GRE-AFS Working Paper No. 5-2

5th GRE-AFS Informal meeting
28-30 October 2003, Bonn

PROPOSAL FOR DRAFT AMENDMENTS TO REGULATION No. 48

(Installation of lighting and light-signalling devices)

Apparent surfaces of lighting units 1 through 11 of an AFS (example)

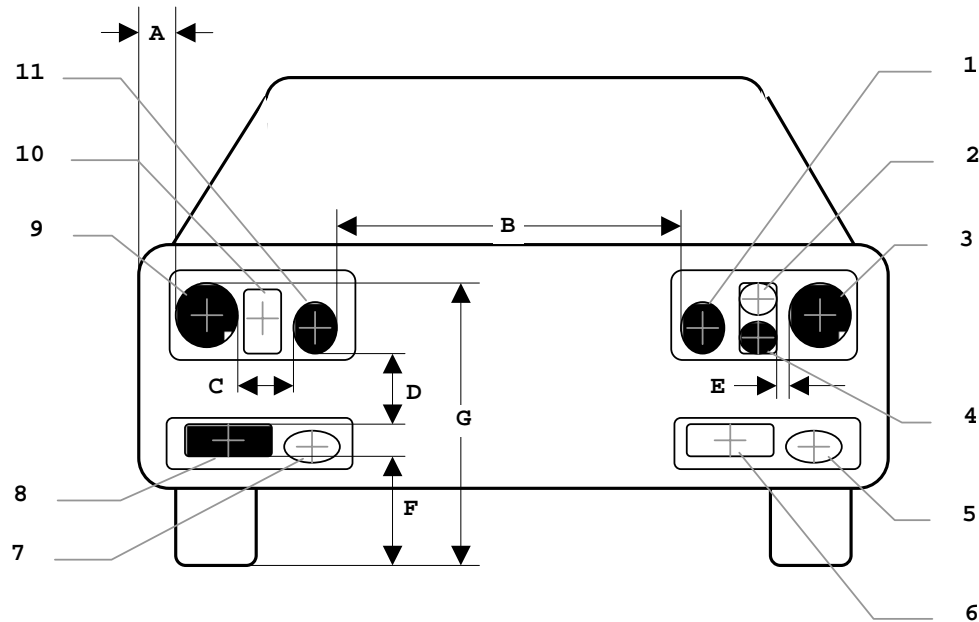
6.20.4.1.1. *Two symmetrically placed lighting units shall be positioned at a height in compliance with the requirements of the relevant paragraphs 6.1.4. and 6.2.4.,*

where "Two symmetrically placed lighting units" shall be understood to be two lighting units, one on each side of the vehicle, positioned such that the (geometric) centres of gravity of their apparent surfaces are at the same height and at the same distance from the vehicle's longitudinal median plane within a tolerance of 50 mm, each; their light emitting surfaces, illuminating surfaces, and light outputs, however, may differ.

6.20.4.1.2. *Additional lighting units, if any, on either side of the vehicle shall be positioned at a distance not exceeding 140 mm 7/ in horizontal direction (E in the figure) and 400 mm in vertical direction above or below (D in the figure) from the nearest lighting unit;*

6.20.4.1.3. *None of the additional lighting units described in paragraph 6.20.4.1.2. above shall be positioned lower than 250 mm (F in the figure) nor higher than [950 /1200 /1500] mm (G in the figure) above the ground;*

the outer edge of the apparent surface of at least one lighting unit on each side of the vehicle shall not be more than 400 mm from the extreme outer edge of the vehicle (A in the figure); and,

the distance between the inner edges of the apparent surfaces of the lighting units on the right and left hand side of the vehicle (B in the figure) shall be not less than 600 mm, or, except for category M₁ and N₁ vehicles not less than 400 mm when the overall width of the vehicle is less than 1300 mm.
